TITLE PERCOLATION CERTIFICATION PLAN REVISION AND PLOT PLAN		OWNED/BUILDER: Approved Septic System Plan Howard County Health Department Columbia, MD 21046		PROPOSED ELEVATIONS: TOP OF BENCHMARK IN AIR: 424.20 TOP OF FOUNDATION WALL: 424.00 TOP OF FIRST FLOOR: 424.00 BRIGHT OUT OF HOUSE: 424.07 BRIGHT SETS FINE: 424.00 BRIGHT OUT OF TANK: 424.07 BRIGHT SETS FINE: 424.00 BRIGHT OUT OF PLUMB: 424.00 BRIGHT SETS DISTRIBUTION BOX: 424.00 BRIGHT OUT OF DISTRIBUTION BOX: 424.00 BRIGHT SETS TRENCH: 424.00	
DATE: 6.12.2008 SCALE: 1:50		PROJECT NAME: 3 Bedroom SFD as shown R. Buck Signature		GRADE AT HOUSE ENTRY: 424.75 GRADE AT SEPTIC TANK: 424.00 GRADE AT PLUMB: 424.00 GRADE AT DISTRIBUTION BOX: 424.00 GRADE AT TRENCH: 424.00 FINISH SPECIFICATIONS: IF APPLICABLE OVER-CALL OR CALL APPROVAL OVER 11' OVERLAY

RE: Revised Perc/Cert Plan
12614 Grovewood Court
Clarksville, MD 21029

Owner:	Shawn and Lusan Abrams 12614 Grovewood Court Clarksville, MD 21029	
Title:	Revised Percolation Certification Plan for 12614 Grovewood Court	
Subdivision:	Preserve at Clarksville Lot 11	
Drawing Prepared By:	RHINE LANDSCAPING, LLC MHC # 21778 PO Box 1556, Sparks, MD 410-442-2445 www.rhinelandscaping.com	
Tax Ma

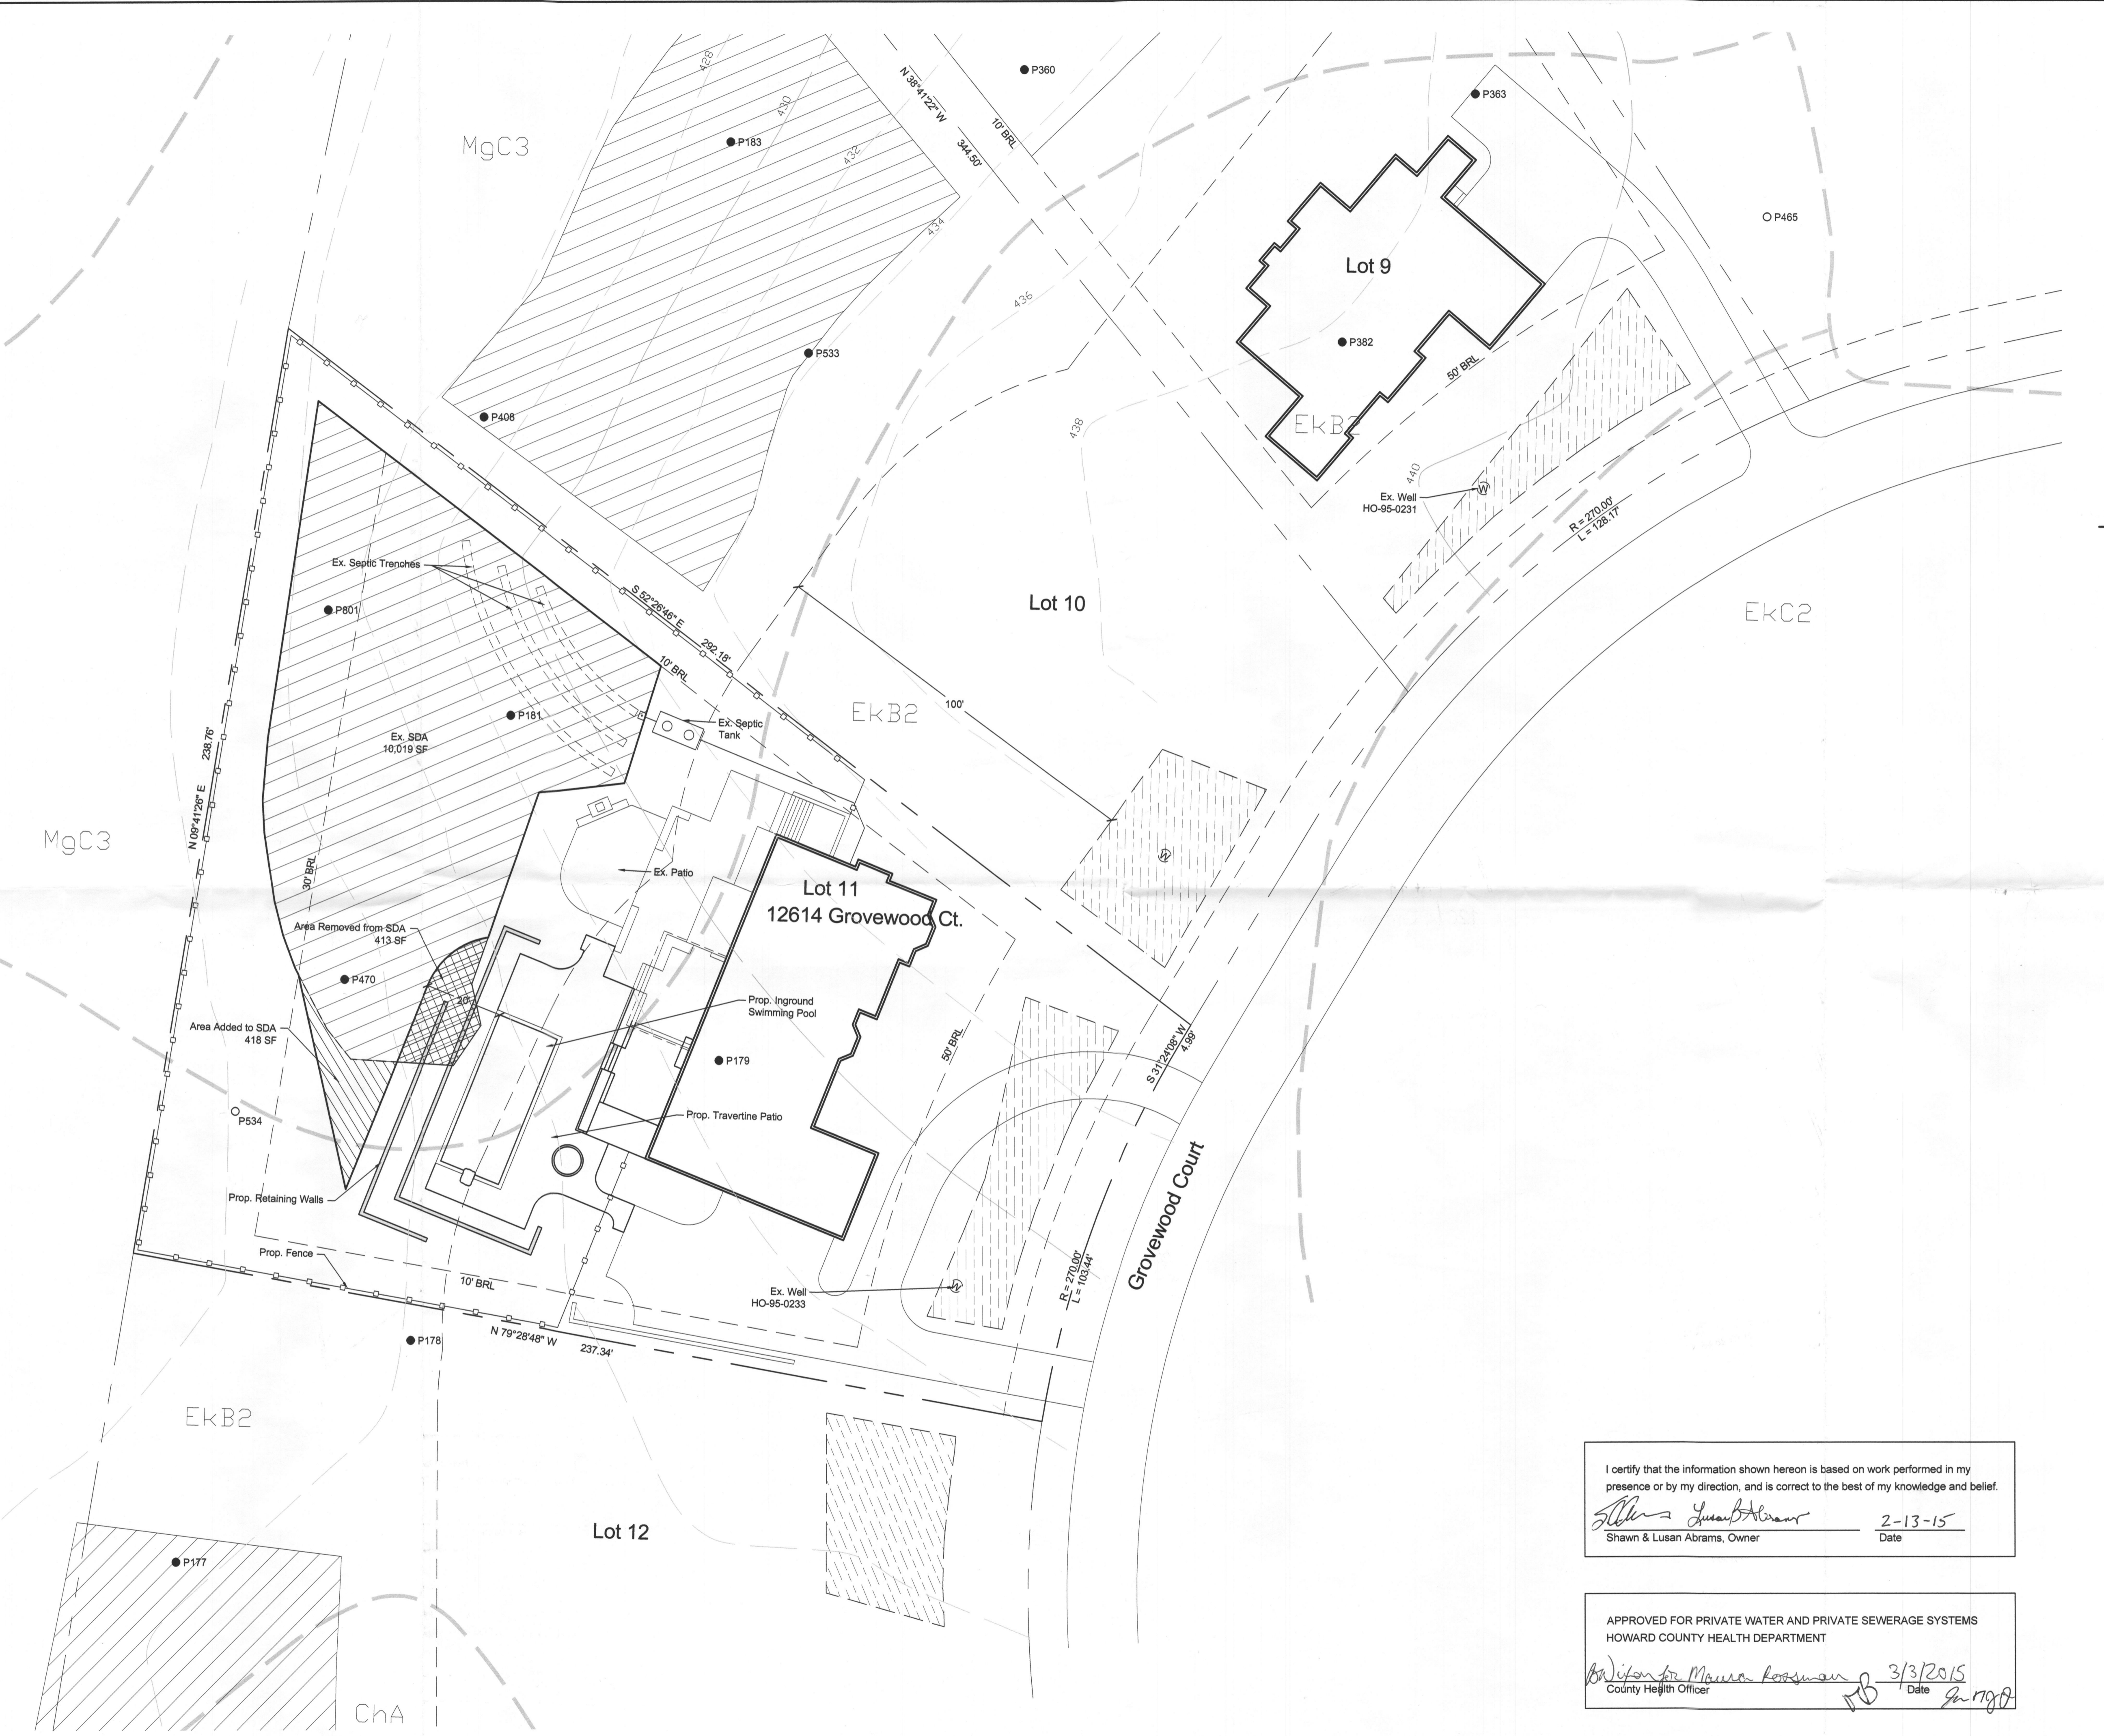
6. This area designates a private sewage easement of at least 10,000 sq. ft. as required by the Maryland Department of Environment for individual sewage disposal. Improvements of any nature in this easement are restricted. This easement shall become null and void upon connection to a public sewerage system. The County Health Officer shall have authority to grant adjustments to the private sewage easement. Recordation of a revised sewage easement shall not be necessary.
7. The purpose for this Revised Percolation Certification Plan is to adjust the existing sewage easement to accommodate construction of an in-ground swimming pool.
